COBRA Bailout System: Various Issues – JFD Guidance Note

COBRA Guidance Note

The purpose of this Product Guidance Note is to share various (mostly minor) issues which have occurred recently and provide information relating to future changes.

Figure 5 - Piston Assembly Showing Positive Pressure Rod

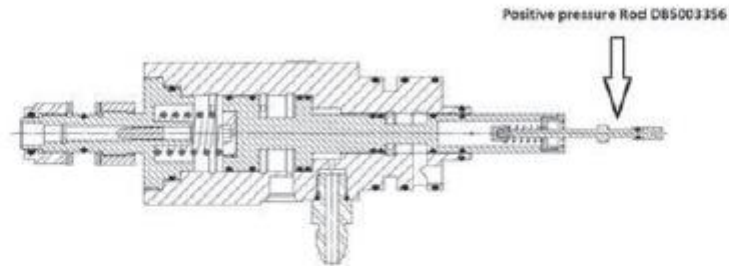
Various reports have been received relating to bending of the positive pressure rod DB5003356.

Likely reasons for bending to this rod are adjusting the demand valve setting via the diaphragm opening or manually purging the set to drain the cylinders more quickly. If either of these techniques is used, care must be taken to not damage the positive pressure rod.
